# Additional Information Requested for Validation

Application for the conversion and change of use of an existing commercial holiday let (restricted C3) into a residential dwellinghouses (C3) and division of residential curtilage at Moor Farm, Black Lane, Doddington

Date: January 2023

Figure 1—image showing materials, recycled brick, pantiles, limestone paving, window/door profile and colour of staining to wooden doors and windows

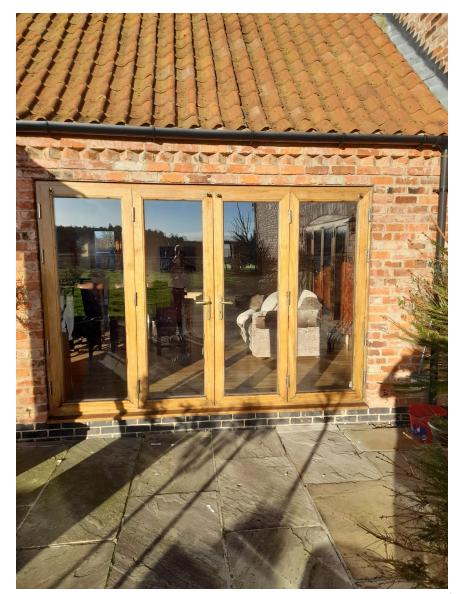
- **1.3** This report clarifies the answers to four questions posed by NKDC and summarised below:-
- Question 1: Request to complete a CIL form;
- Question 2: Clarify the details of any installation of new doors and windows;

- Question 3: Amend the materials section of the application form;
- Question 4: Further details of boundary treatments.
- **1.4 Response to Question 1**—Having reviewed the proposal with the NKDC CIL Officer, it is her opinion that the proposal is not CIL liable. A completed form is still required to confirm this. The completed form accompanies this report File ref Appendix 1—CIL Form

- 36mm triple glazed units to comply with Building Regulation Approved Document L.;
- All full height glazing to be safety glass.
- 1.8 Figure 1 adjacent is extra information to demonstrate the existing materials that have been used on site during the original barn conversion. Any new materials used will match existing. For avoidance of doubt all bricks will be matched in size and colour recycled traditional Victorian Lincolnshire brick as already used within the development. Reclaimed bricks will be used to brick up any areas that require infilling.

- **1.9** Refer to drawing 106 (08) proposed plans to identify all new groundworks. All materials to be used will be as described above and shown in figure 1. The applicant requests that any further information required, be dealt with as a condition attached to planning permission.
